SERVICE BULLETIN #23-69

SUBJECT: Oil Leak at Gearbox Sprocket, Model A75 Rocket 3

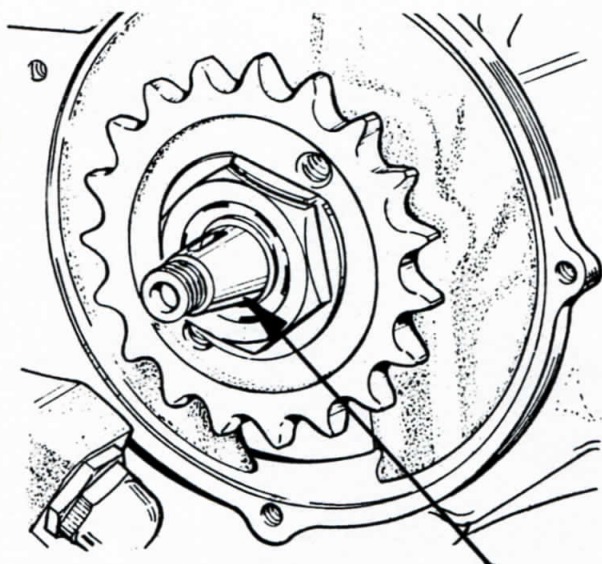
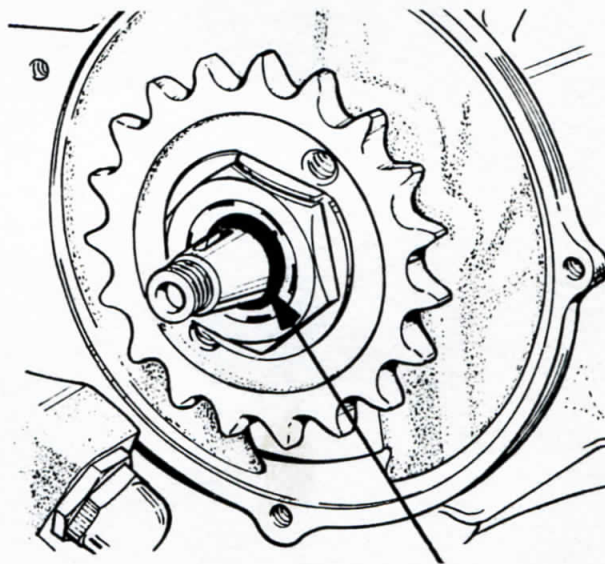
An oil seal has been added at the gearbox mainshaft between the end of the high speed gear and the clutch hub.

This oil seal, Part No. 57-1956 will prevent gearbox oil from seeping out along the gearbox mainshaft and the high gear bush as shown in the illustrations below:

Illustration showing area of possible oil leakage at gearbox mainshaft high gear bush.

Illustration showing oil seal Part No. 57-1956 fitted on gearbox mainshaft.
